Florida Department of Transportation

DCE MEMORANDUM NO. 19-08
(FHWA Approved: 7/16/08)

SUBJECT: CHANGES TO INDEX 11200, 11300 AND 11860

This memo is issued to allow the contractor to use the recent changes to Index 11200 and 11860 of the Design Standards. Please refer to the attached Design Standards.

Sheet No. 1 of 3
Index No. 11200

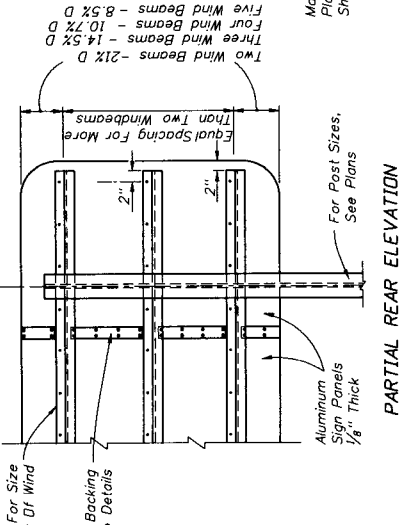
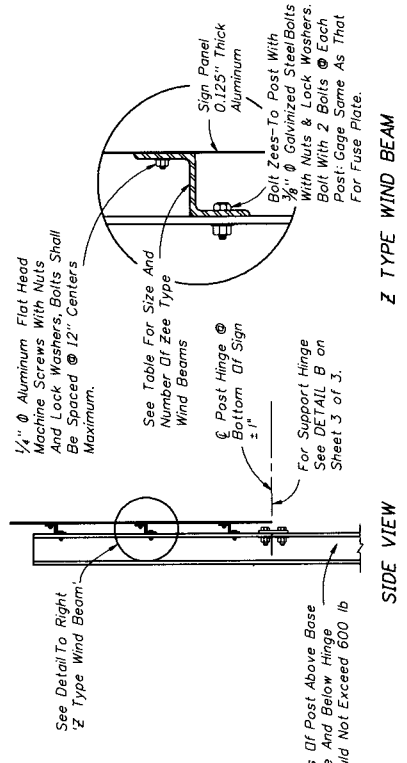
- Index 11200, Sheet 1 or 3, was modified to allow a horizontal panel splice at an interior Z bar support if the sign panel is deeper than **10 feet**, (instead of 12 feet).

Note: If the sign panels are deeper than 10', horizontal panel splice is allowed as on plate Z. For support, strip drawings shall be required. Minimum panel section width = 2'-6".

DATE	BY	DESCRIPTION
07/01/07	L.W.	Updated Sign Strip Backing Strip DETAIL. Note revised to 10' instead of 12' in BACKING STRIP DETAIL.

2008 Interim Design Standard
 OVERHEAD SIGN STRUCTURES
 Sheet No. 01/01/08
 Index No. 1 of 1
11300

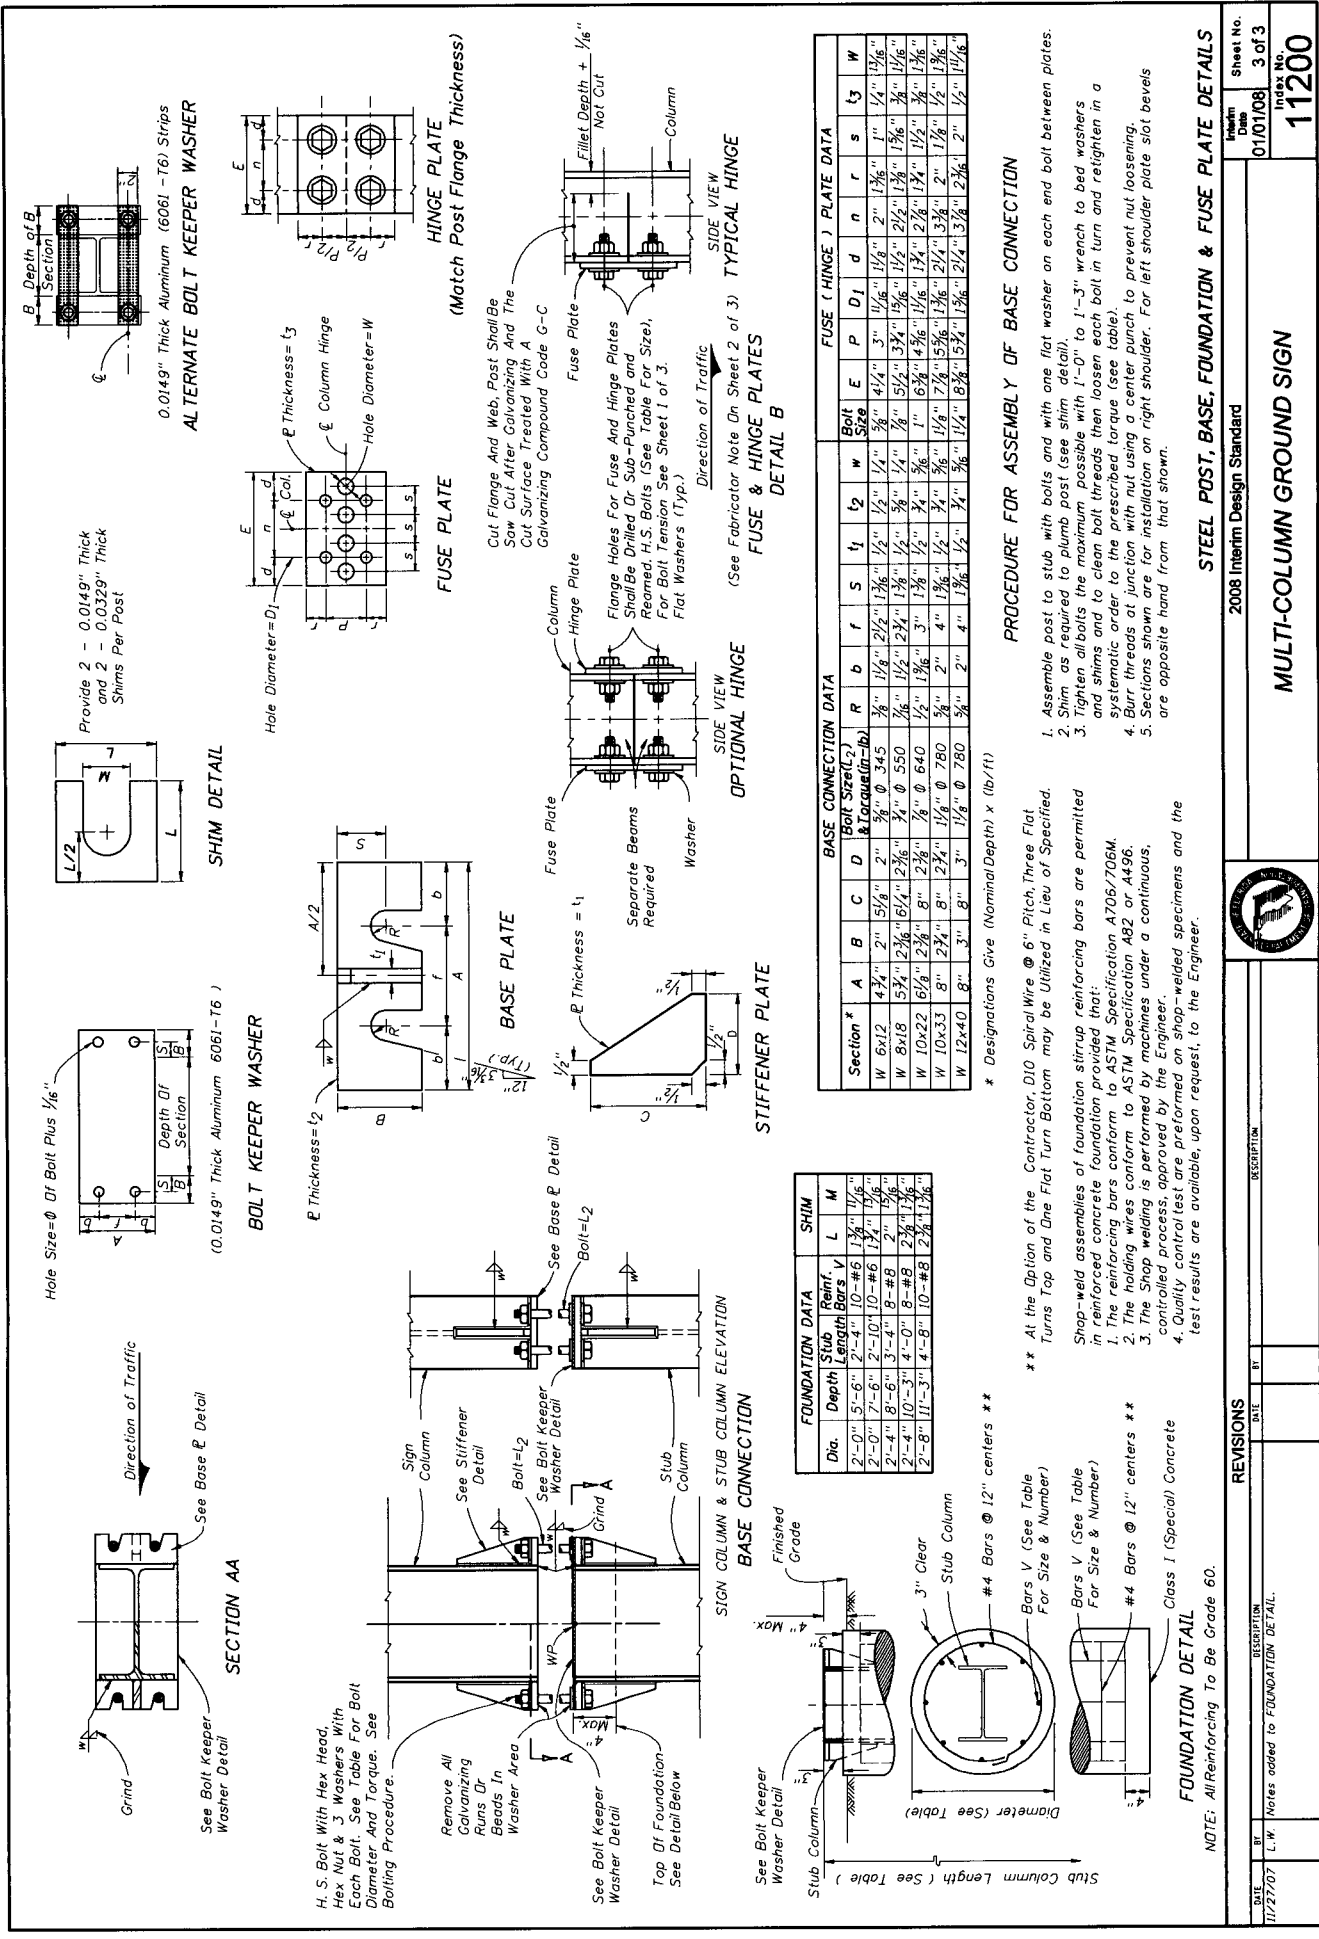
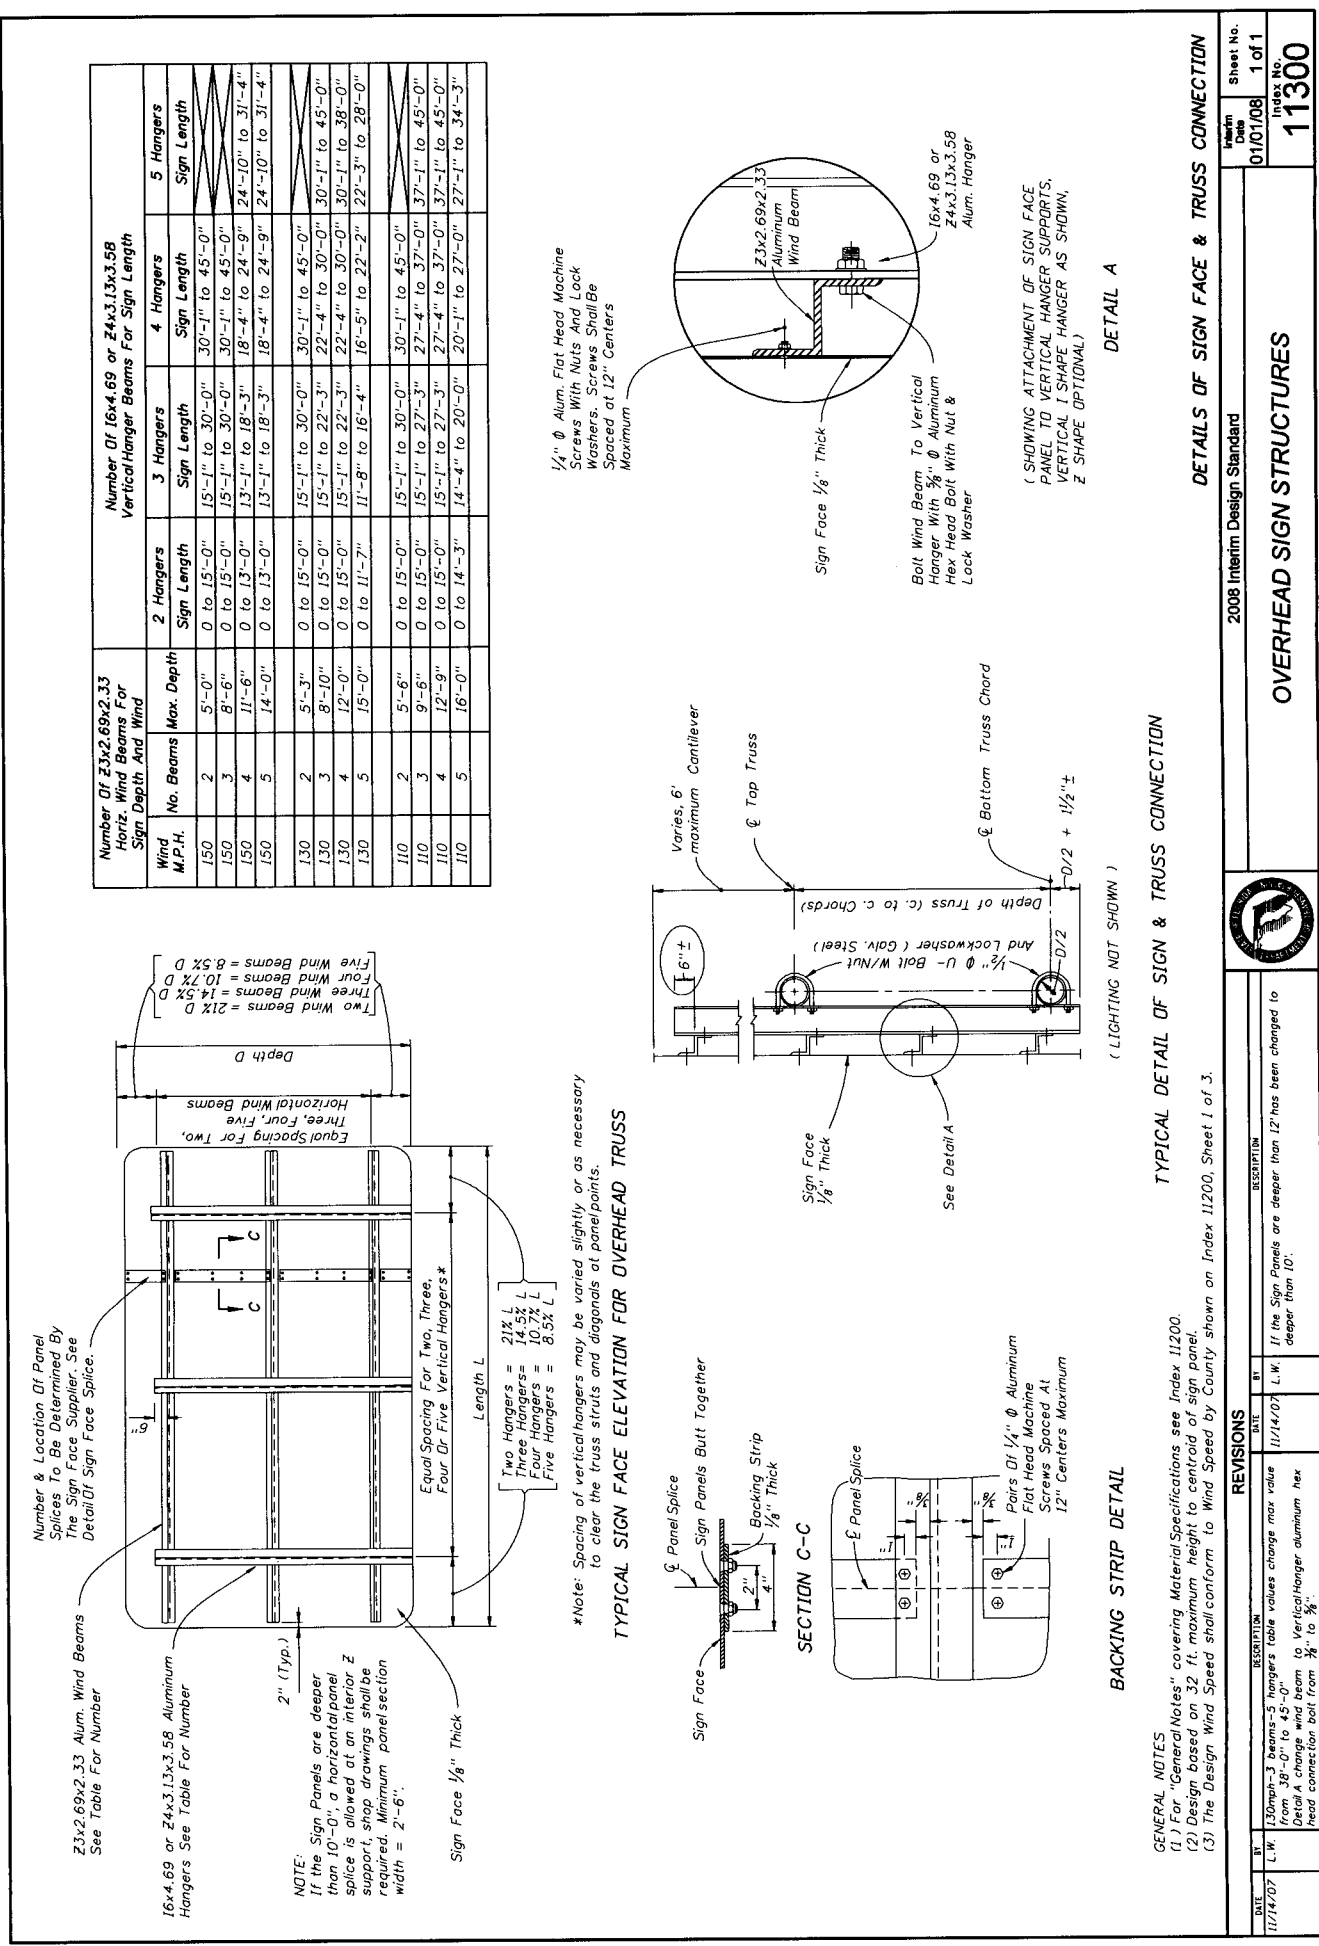
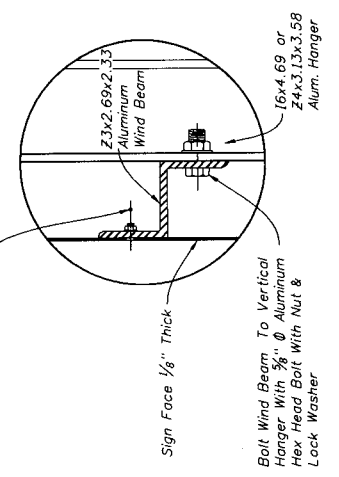
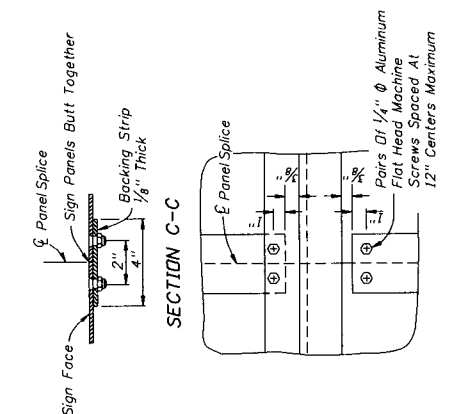
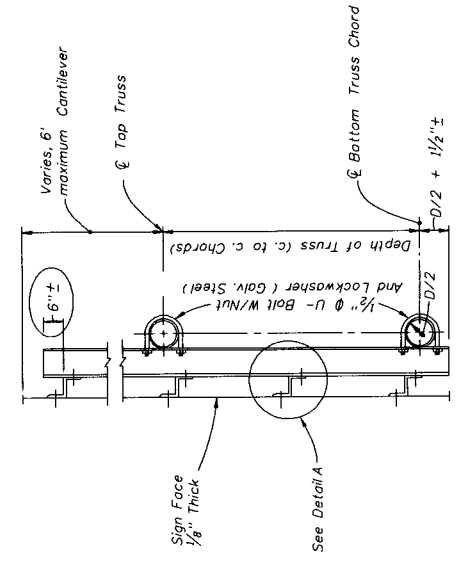
- Index 11200, Sheet 3 of 3, was modified to allow **Class I (Special) Concrete** in the foundation (instead of Class II Concrete).
- Index 11300, Sheet 1 of 1, was modified to allow a horizontal panel splice at an interior Z bar support if the sign panel is deeper than **10 feet**, (instead of 12 feet).

DATE	BY	REVISION
11/14/07	L.W.	150mph-3 Beams-5 Hangers table values change max value from 10'-0" to 14'-0" L.W. If the Sign Panels are deeper than 12' has been changed to deeper than 10'.
11/14/07	L.W.	Detail A change wind beam to Vertical-Hanger aluminum Max head connection bolt from 3/8" to 3/4".
